# **STUDER**

### **D820 MCH Modifications and Update to S/W Version 3.0**

SI 159/93, Order No. 10.85.7350 (ED 0693)

**D820 MCH - MODIFICATIONS AND S/W UPDATE V3.0**

Modification Tape Deck Disp. Driver 1.820.768.84

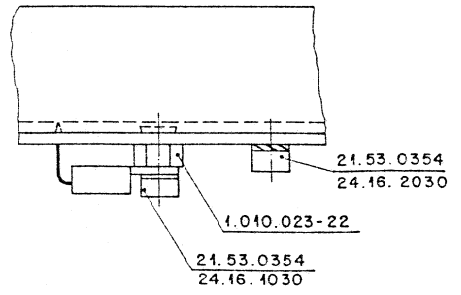
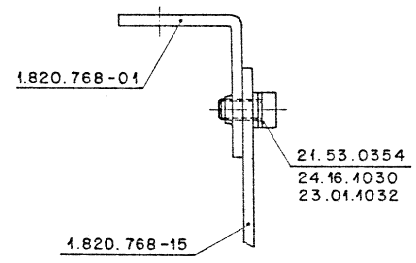
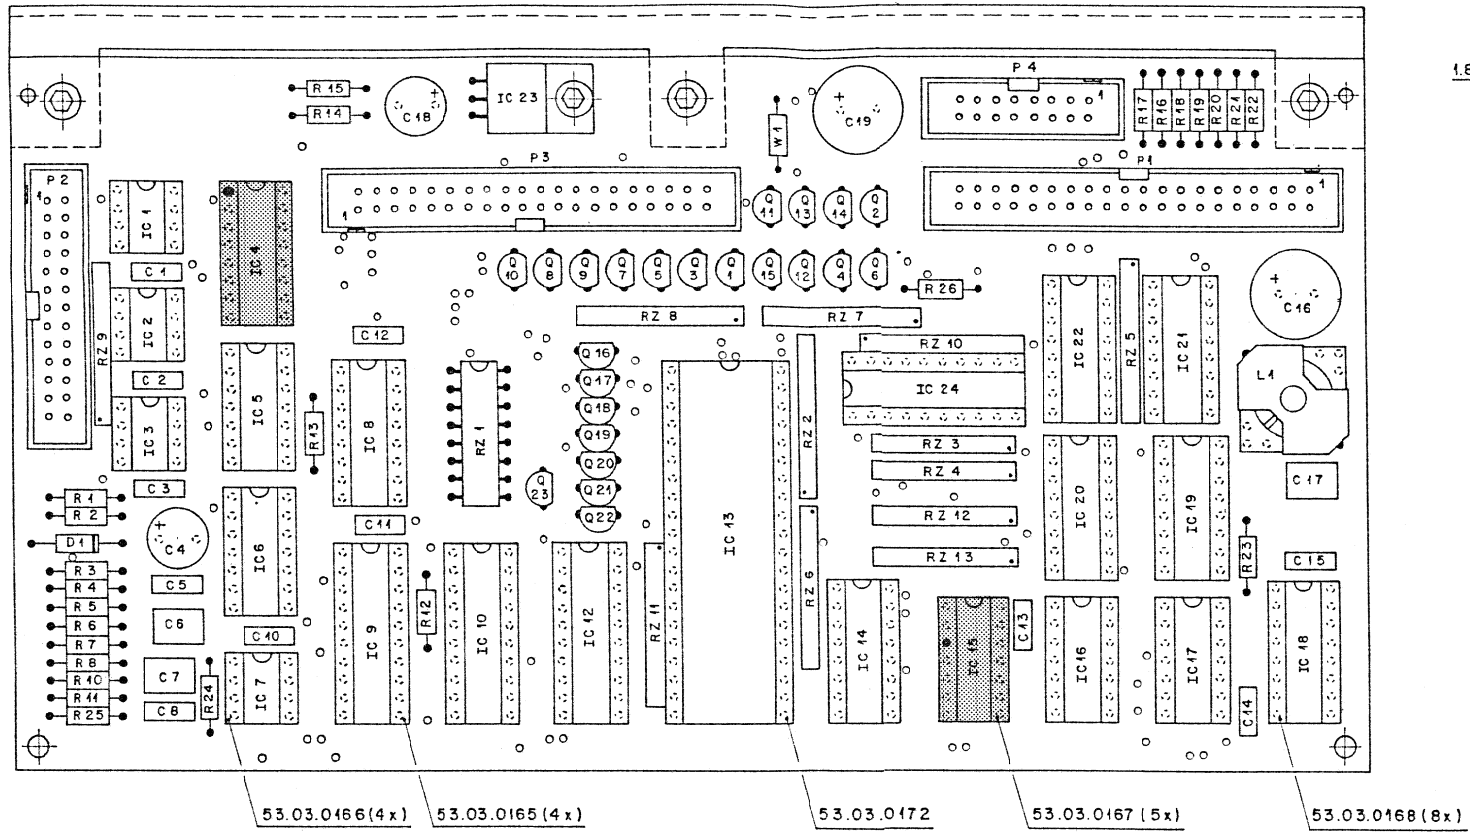
Problem:

Incorrect initialisation of Parallel Remote port.

Cause:

Chip reset delayed.

Connect IC04, pin 1 to IC15 (HC14), pin 3. (Schematic, mark "M").

Change board index to new 1.820.768.85.
